1 **Comment**

2 (TDL #162 from D2.1)

19 **33.2.8.5.1 PSE PI pair-to-pair [effective](#) resistance and current unbalance**

60 **Figure 33-X1B-1—PSE PI unbalance specification and E2EP2PRunb**

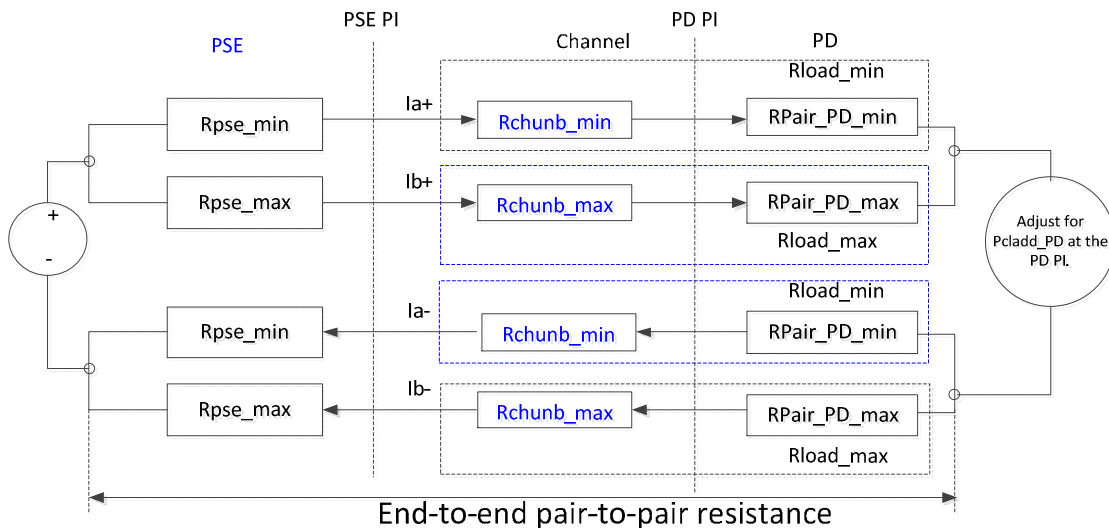
56 [Figure 33-X1 illustrates the relationship between \$R_{PSE_max}\$ and \$R_{PSE_min}\$ effective resistances at the PSE PI](#)
57 [as specified by Equation 33-15 and the rest of the end to end pair to pair effective resistance components.](#)

58 [A PSE shall not source more than \$I_{Con-2P_unb_min}\$ on any pair when connected to a load as shown in Figure](#)
59 [33-X1, using values of \$R_{load_min}\$ and \$R_{load_max}\$ as specified in Table 33-X1.](#)

94 **Figure 33-X2B-4 — Current unbalance ~~test-verification~~ circuit**

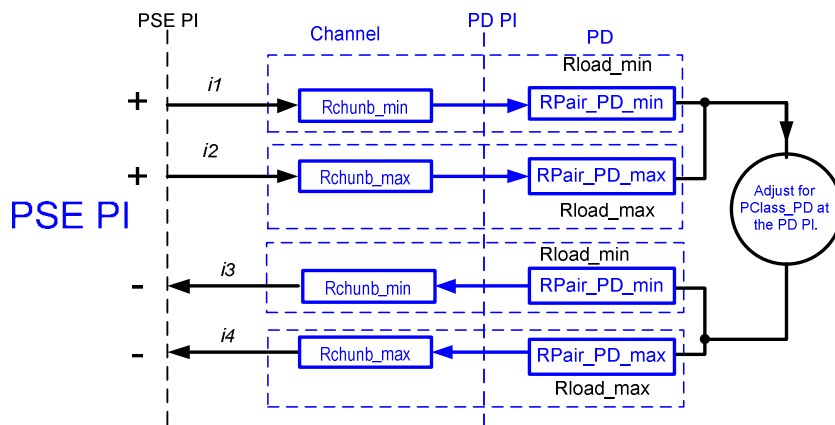
91 **Move Figure 33B-4 to this location with the following marked updates.**

96 The current unbalance ~~test-verification~~ circuit is shown in Figure 33-X2. The evaluation method is described
 97 below:

98 1) Use R_{load_min} and R_{load_max} from Table 33-X1B-1 for R_{load} at low channel resistance conditions.

99 2) With the PSE powered on, adjust the load to P_{class_PD} .

100 3) Measure I_1 , I_2 , I_3 and I_4 .

101 4) Swap R_{load_max} , R_{load_min} , repeat steps 1-2 and 2-3.

104 ~~7) Repeat steps 1-5-6~~ for R_{load_min} and R_{load_max} from Table 33-X1B-1 for R_{load} at high channel
 105 resistance conditions.

167 **Figure 33A-X1 – Common mode Pair-to-pair channel resistance unbalance**

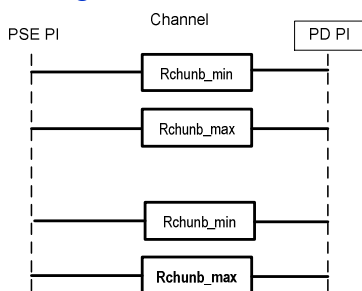
Figure 33A-XX was added to differentiate between R_{ch} term used from PSE PI to PD PI and back and the channel resistance of pair of wires and their connectors from PSE PI to PD PI (one way) when they are unbalanced are used in this Annex and all related P2Punb clauses.

165 **Add Figure 33A-X1**

217 ~~Figure 33B-1—PSE PI unbalance specification and E2EP2P Runb~~

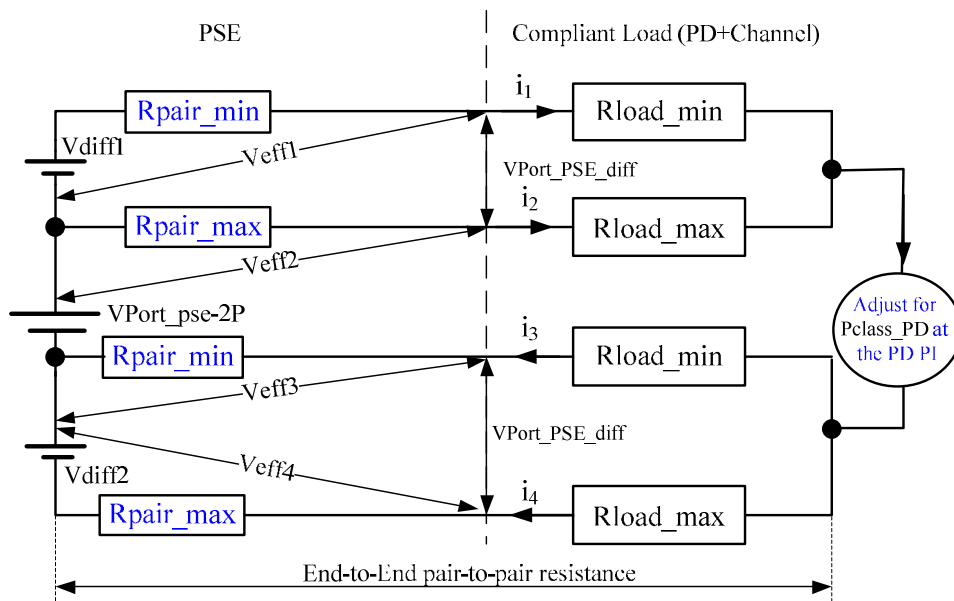
214 **Delete Figure 33B-1. It was updated and moved to 33.2.8.5.1**

215 **Delete Table 33B-1. It was updated and moved to 33.2.8.5.1**

239
240 Figure 33B-3 – Effective resistance **testverification** circuit

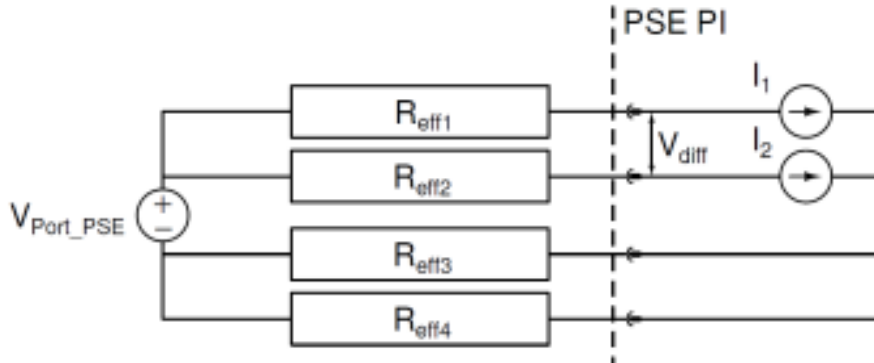
228 **Update Figure 33B-2 as follows:**

Add to TDL: Ken to verify that the following verificationmodel works in simulations

235
236 Figure 33B-3 shows a possible **testverification** circuit for effective resistance measurements on a PSE port for
237 evaluating conformance to Equation (33–15) if the internal circuits are not accessible. In Figure 33B-3, the
238 positive pairs of the same polarity are shown as an example. The same concept applies to the negative pairs.

241 The Effective Resistance **verificationTest** Procedure is described below:

- 242
- 243 1) With the PSE powered on, set the following current values
- 244 a. $10\text{ mA} < I_2 < 50\text{ mA}$
- 245 b. $I_1 = 0.5 \times (P_{\text{max}}/V_{\text{port}}) - I_2$
- 246 2) Measure V_{diff} .
- 247 3) Reduce I_1 by 20% ($=I_1'$). Ensure I_2 remains unchanged.
- 248 4) Measure V_{diff}' in the same manner as V_{diff} .
- 249 5) Calculate R_{eff1} : $R_{\text{eff1}} = [(V_{\text{diff}}) - (V_{\text{diff}}')] / (I_1 - I_1')$
- 250 7) Repeat procedure for R_{eff2} , with I_1, I_2 values swapped.
- 251 8) Repeat procedure for $R_{\text{eff3}}, R_{\text{eff4}}$.
- 252 9) Evaluate compliance of R_{eff1} and R_{eff2} with Equation (33–15). Evaluate compliance of R_{eff3} and
- 253 R_{eff4} with Equation (33–15).
